V2500-D5 PROPULSION SYSTEMS NON-MODIFICATION SERVICE BULLETIN

This document transmits the Revision 1 of Non-Modification Service Bulletin V2500-ENG-72-0630.

NON-MODIFICATION SERVICE BULLETIN – NO.4 BEARING SCAVENGE TUBE ASSEMBLY REPLACEMENT
PROCEDURE

LOCATION OF MARKING POSITION ON NO.4 BEARING INTERNAL SCAVENGE TUBE
FIGURE 1

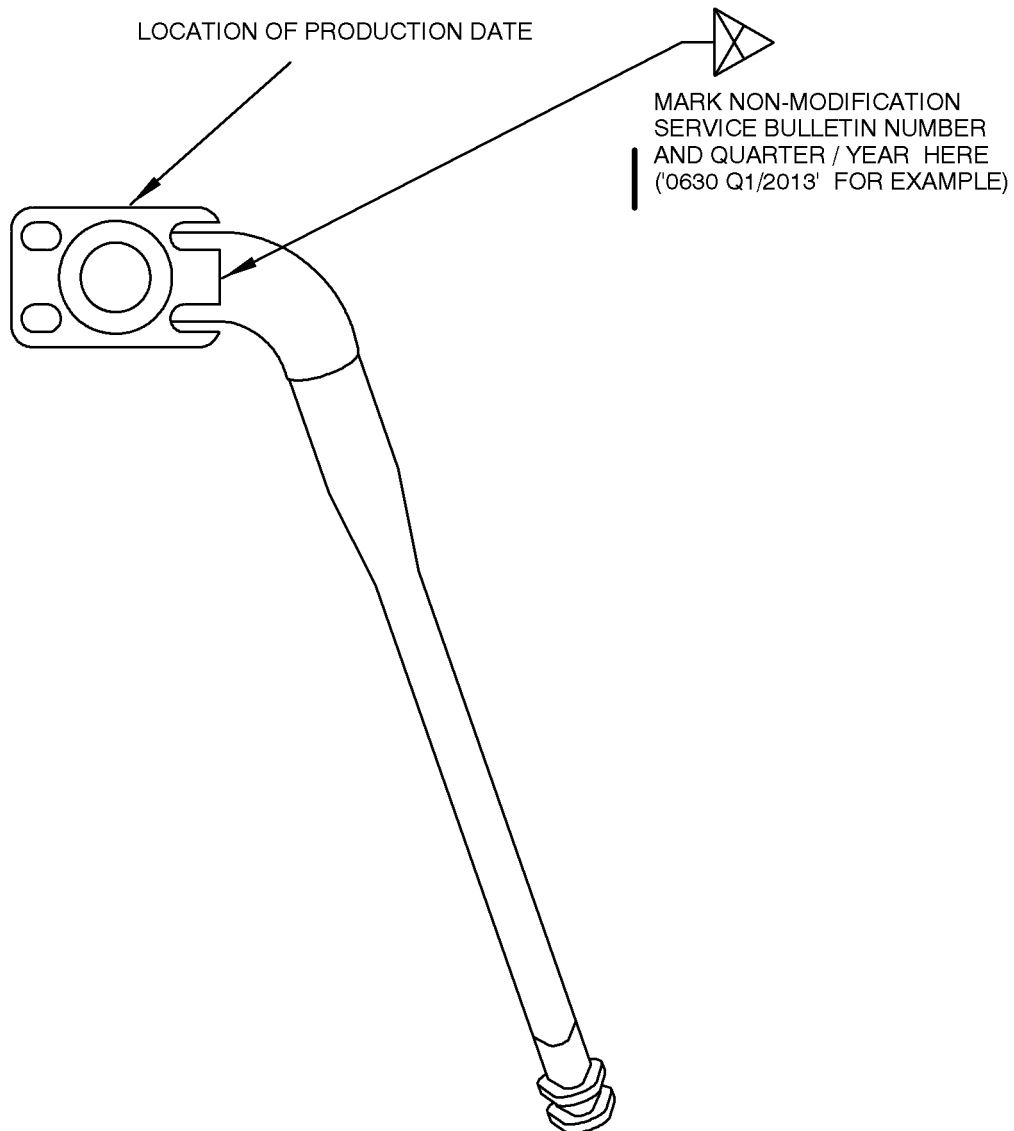
- R (3) Obtain a new No.4 Bearing Scavenge Internal Tube, PN 2A2074-01.
- R (4) Mark the new tube at the location shown in Figure 1 with this
R Non-Modification Service Bulletin number and quarter/year. For example,
R mark the tube "0630, Q1/2013" if the tube was replaced in the 1st quarter
R of the year 2013. See Reference 3, Standard Practices Manual,
R Chapter/Section 70-09-00, Marking of Parts. Approved marking methods are
R deep electrolytic etch, metal stamp (press or roll), or drag impression.

EXAMPLES OF ALIGNED AND MIS-ALIGNED NO.4 BEARING EXTERNAL SCAVENGE TUBE
FIGURE 2

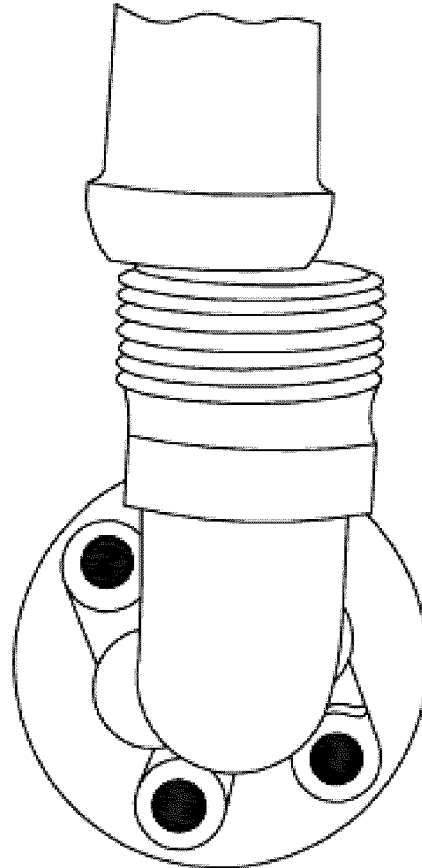
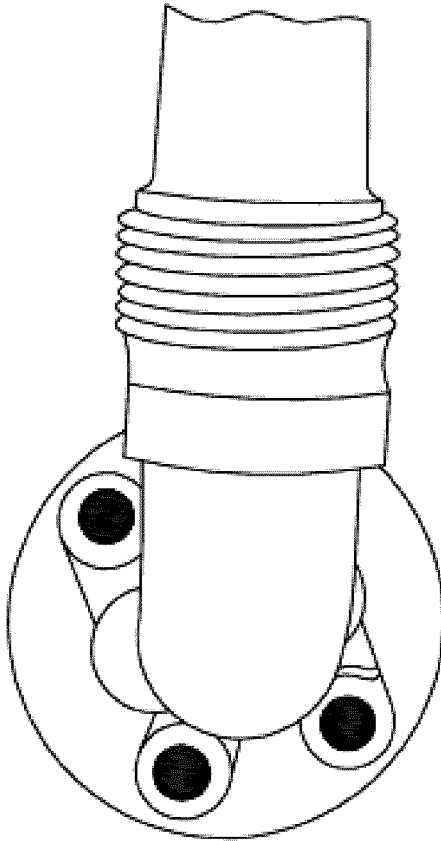
R B Make sure that the tube is still aligned and in free condition. The end of the conical fitting of the tube 55 must be inside the top conical seat of the elbow, PN 2A2514 or PN 2A3951-01 as illustrated in Figure 2 of this Service Bulletin.

CORRECTLY ALIGNED
--- ACCEPT ---

MIS-ALIGNED
--- REJECT ---

R C If the tube is still aligned and in free condition, torque the nut to 566.0 to 611.0 lbfin (63,949 to 69,034 Nm). Use the IAE 1R18003 wrench.

- D If the tube is mis-aligned, reject the tube 55 and replace with the new tube. Repeat steps (i) to (v). Discard the old tube and make it unserviceable in an acceptable manner which is described in FAA - Order: 8120.11 "Disposition of scrap or salvageable aircraft parts and materials", dated 2/12/96.
- E Safety wire the tube nut and tube connector with CoMat 02-126 lockwire.
